To: T10 Technical Committee
 From: Rob Elliott, HP (elliott@hp.com)
 Date: 30 October 2003
 Subject: 03-346r1 SAS-1.1 Pathway recovery priority corrections

A few deadlock scenarios have been discovered and a few rules regarding pathway recovery have been proven to be unclear. They mostly relate to this paragraph in 7.12.4.4:

Figure 3 — All vs any

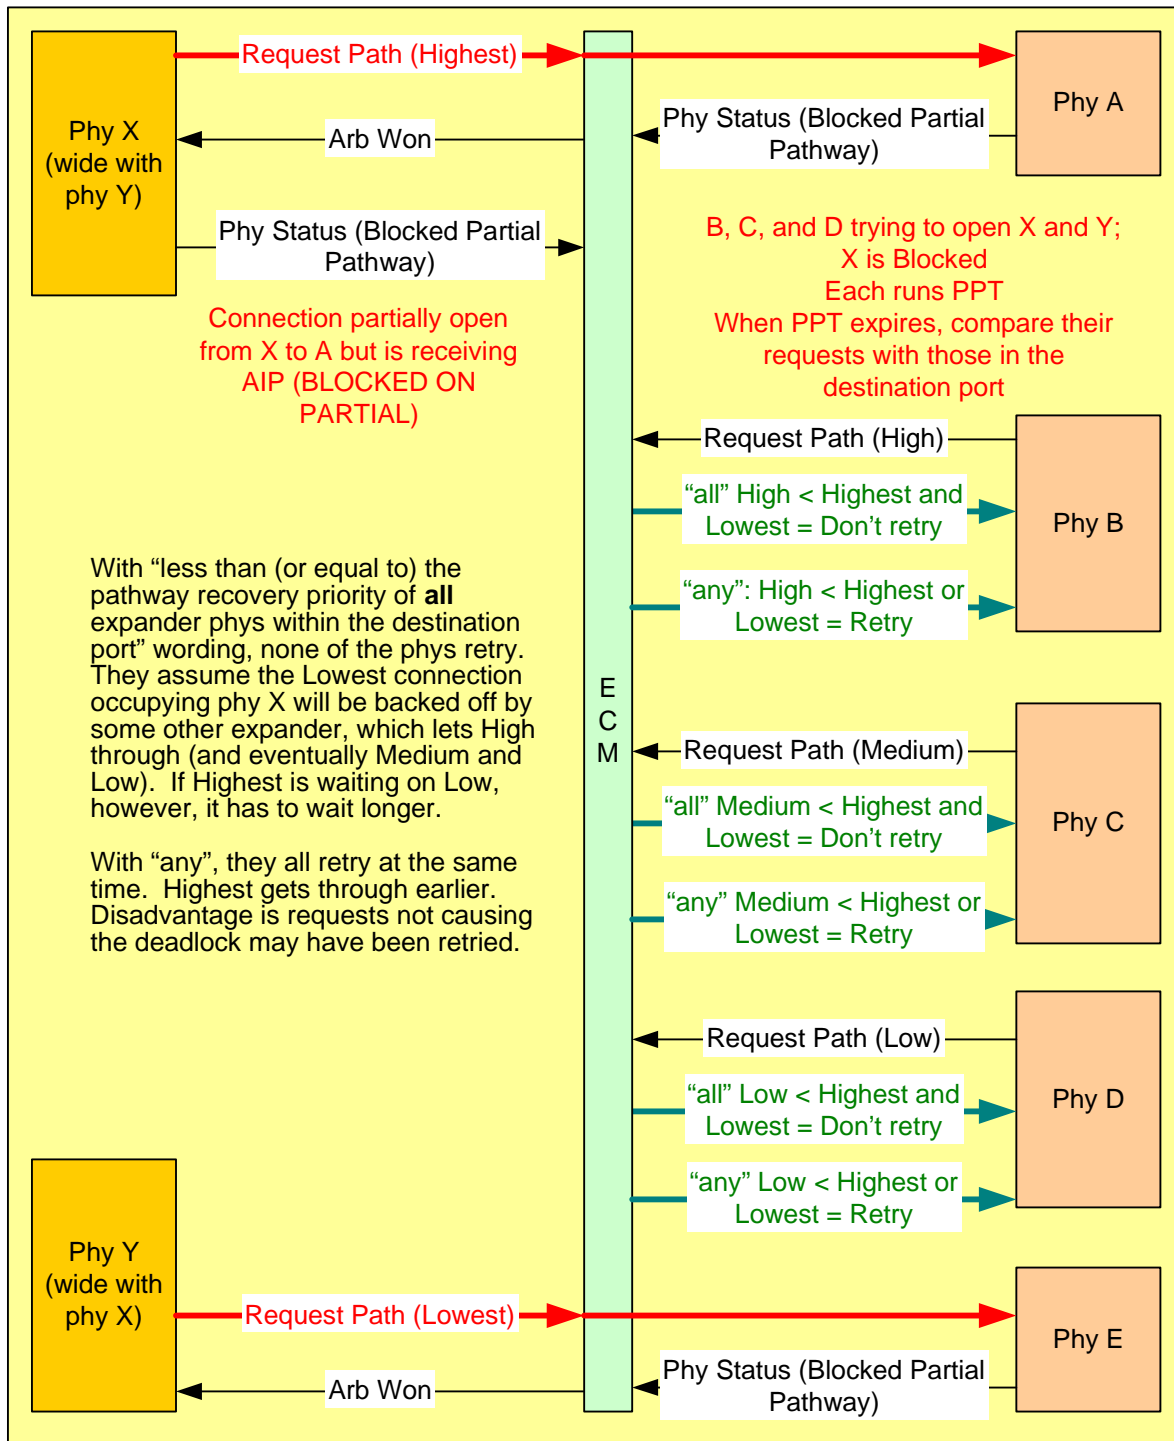
- b) The pathway recovery comparison of the arbitrating phy vs. each of the destination phys needs to be "less than or equal to any" rather than "less than all." With the source SAS address taken from the Transmit Open, the source SAS address can be the same, so a peer request might need to be retried. This request could be equal to a source SAS address in use at the destination port.

Figure 3 shows the effect of comparing “all” vs any” when the destination is a wide port. The current rule is “all”; “any” is proposed instead to resolve deadlocks faster (at the expense of more retries).

- the Partial Pathway Timeout timer expires; and
- the pathway recovery priority of the arbitrating expander phy (i.e., the expander phy requesting the connection) is less than or equal to the pathway recovery priority of ~~all~~ any of the expander phys within the destination port ~~with an arbitration status of WAITING_ON_PARTIAL~~ that are sending Phy Status (Blocked Partial Pathway) responses to the ECM.

Figure 4 — Less than or equal

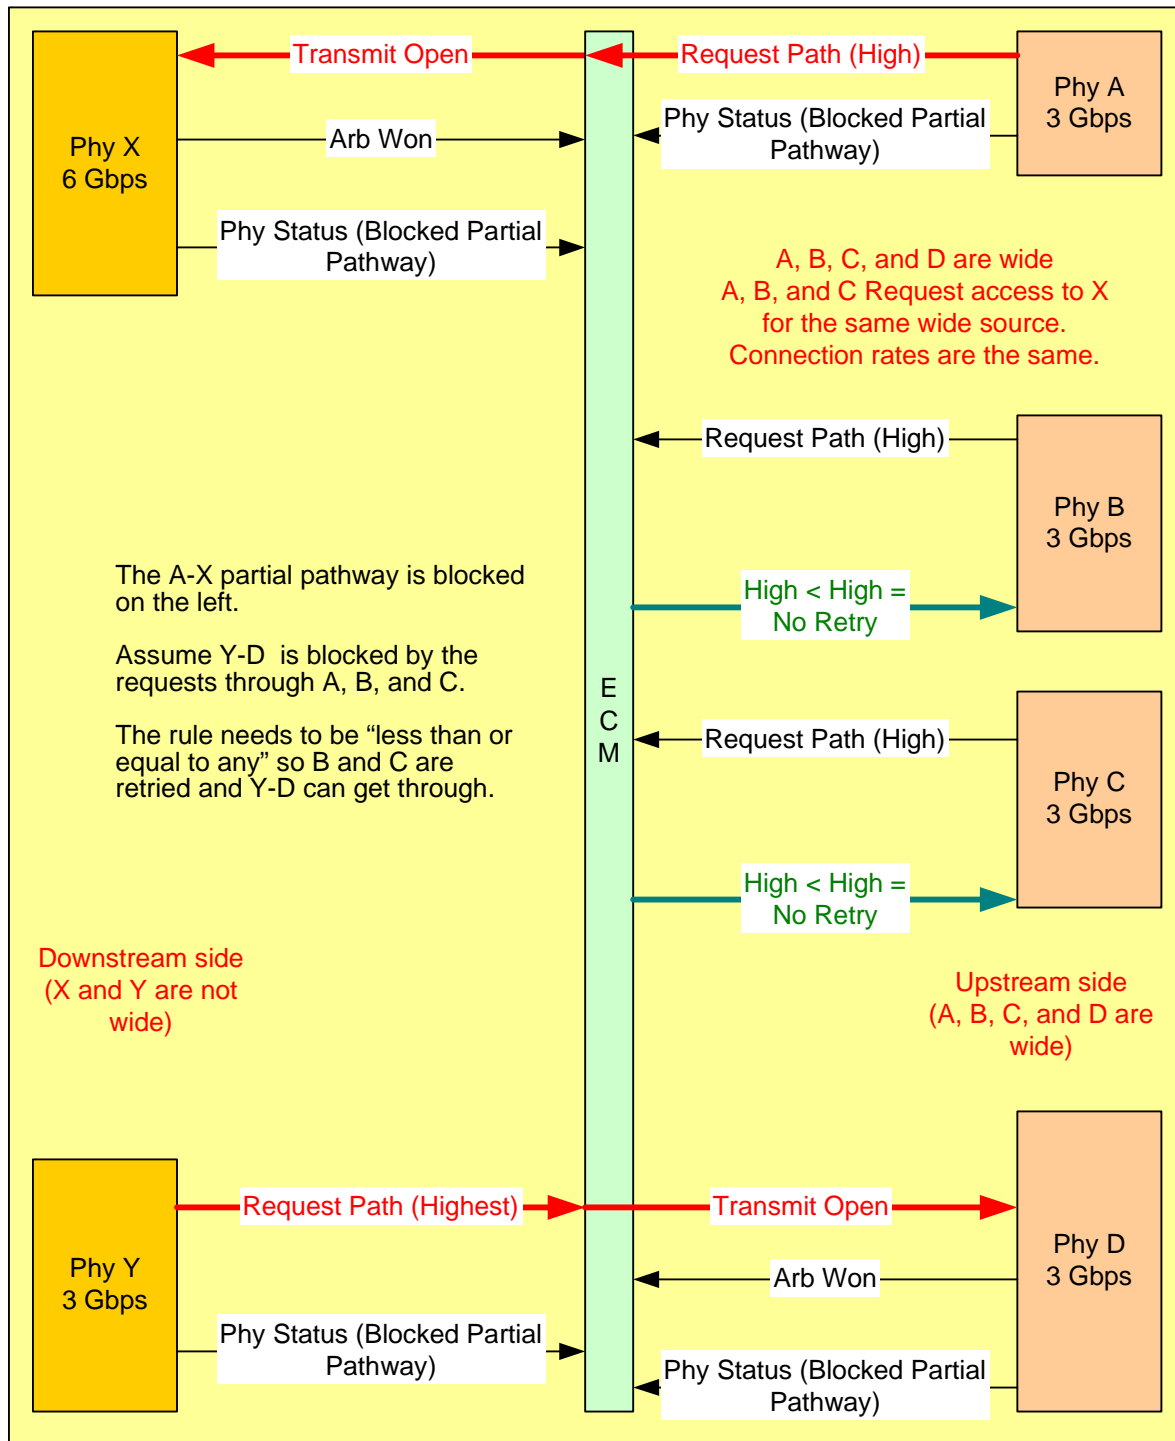
Figure 4 shows a case where the source addresses in pathway recovery priority comparisons are the same, so “less than or equal” is needed rather than “less than”.

Figure 5 — Connection rate example

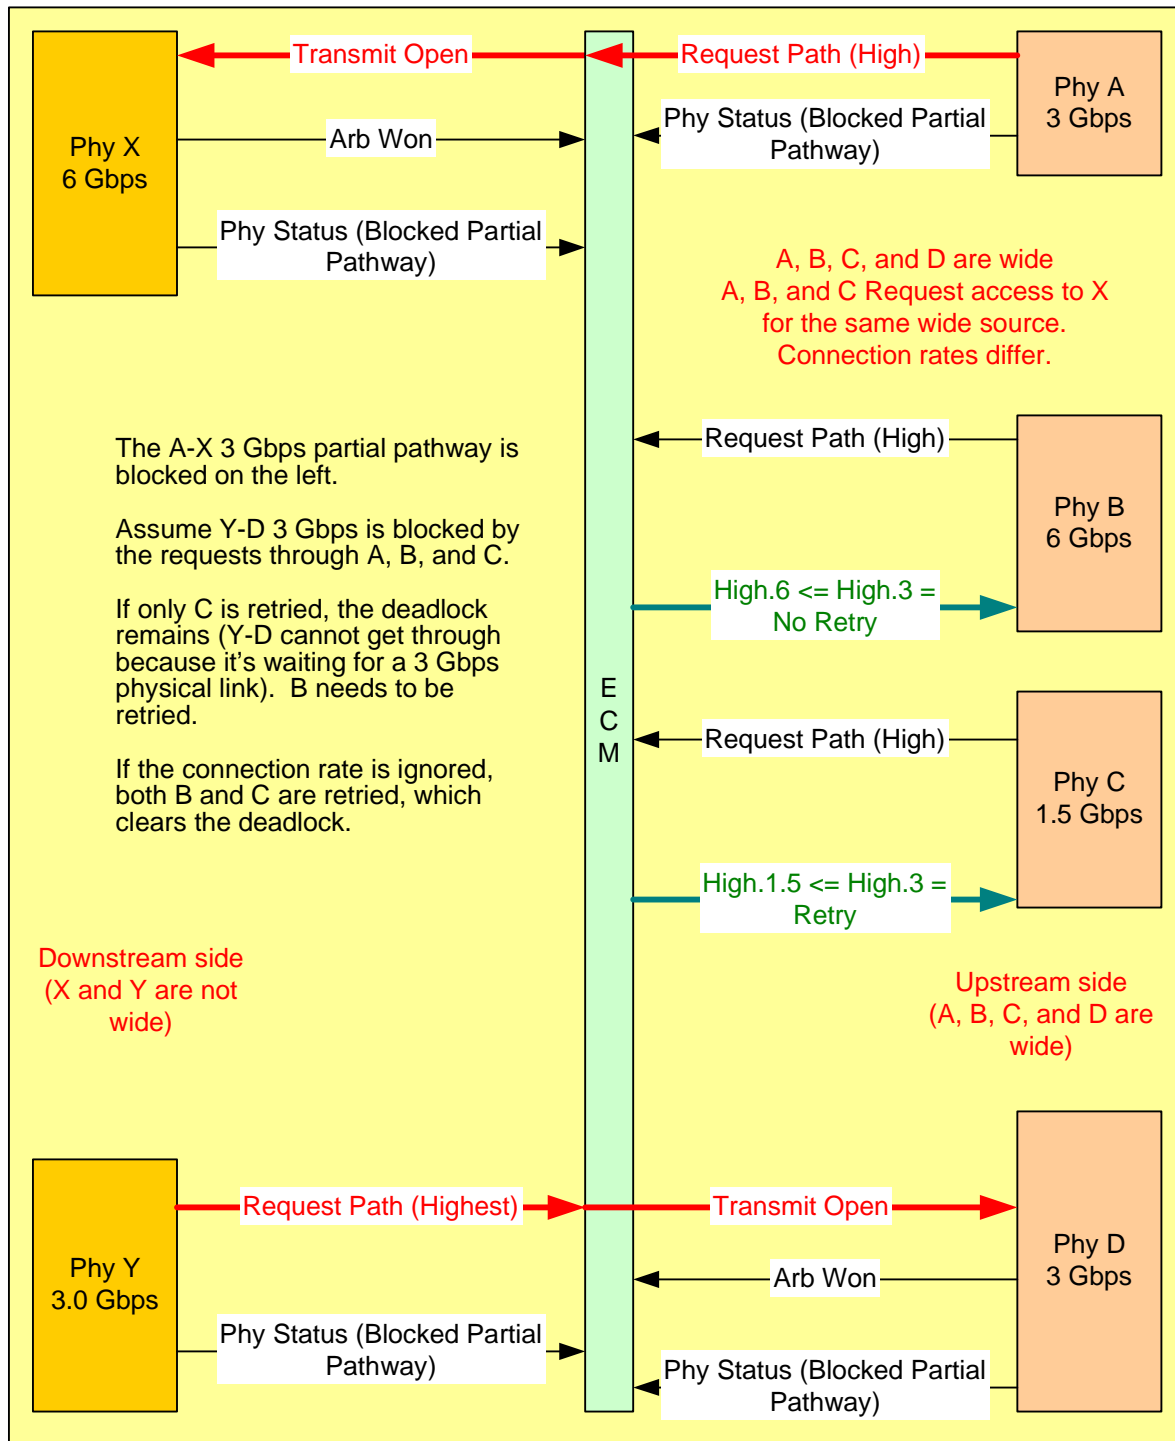
- c) The connection rate field needs to be removed from the pathway recovery priority. If a wide expander port has a mix of link rates (some phys are 1.5 Gbps and others are 3 Gbps) and a deadlock is caused by a set of 3 Gbps connection requests, freeing a 1.5 Gbps phy may not resolve the deadlock. It might not occur until 6 Gbps connections are present, but it should be corrected now.

Figure 5 shows a case where the connection rate needs to be ignored or the connection retried might not break a deadlock. Notice this example requires 6 Gbps which is not yet defined in SAS.

Bits 75-68 71-64 (75 71 is MSB)	Bits 67-5 63-0 (0 is LSB)	Bits 3-0 (0 is LSB)
PATHWAY BLOCKED COUNT field value	SOURCE SAS ADDRESS field value	CONNECTION-RATE field value

Figure 6 — Forward Phy Status from phy to phy

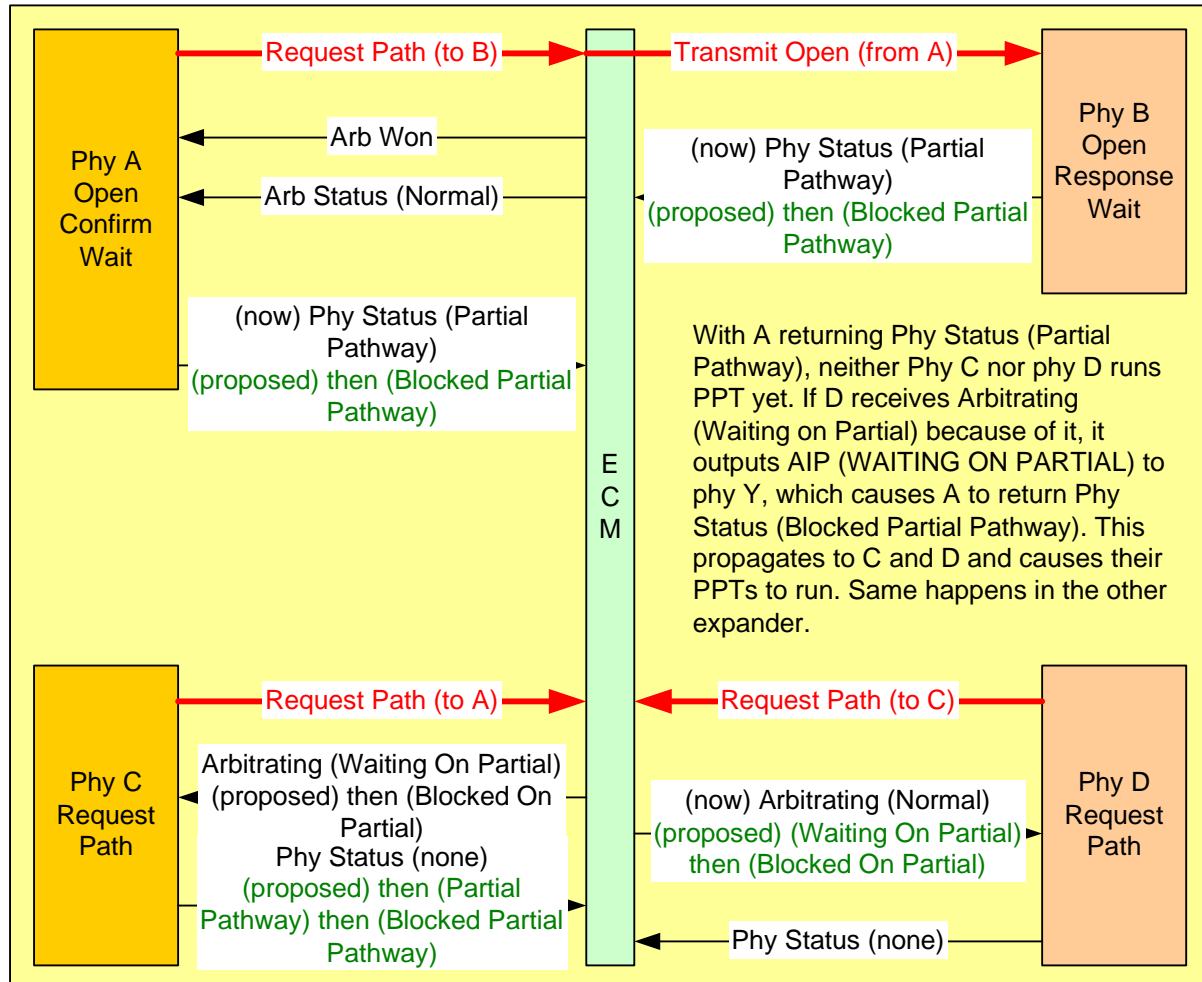
- A) all are Partial and/or Blocked - needs to return Arbitrating (Waiting on Partial).
- e) Phy Status (Blocked Partial Pathway) needs to propagate through phys. If phy A is waiting on phy B which is waiting on phy C which is returning Phy Status (Blocked Partial Pathway), both phy A and phy B need to receive Phy Status (Blocked Partial Pathway) and run their PPTs. Phy Status (Waiting on Partial) needs to be propagated the same way. For consistency, Phy Status (Connected) should be renamed to Phy Status (Connection), also triggered on receipt of Arbitrating (Waiting on Connection), and also be propagated. This becomes the first area in SAS that treats AIP (WAITING ON CONNECTION) differently from AIP (NORMAL) for more than basic forwarding.

Figure 6 shows a case where Phy Status (Partial Pathway) and Phy Status (Blocked Partial Pathway) need to be forwarded from phy to phy.

This state shall repeatedly send a Phy Status (Partial Pathway) response to the ECM. After an Arb Status (Waiting on Partial) confirmation is received, this state shall repeatedly send a Phy Status (Blocked Partial Pathway) response to the ECM.

This state shall repeatedly send a Phy Status (Partial Pathway) response to the ECM. After an AIP Received (Waiting On Partial) message is received, this state shall repeatedly send a Phy Status (Blocked Partial Pathway) response to the ECM.
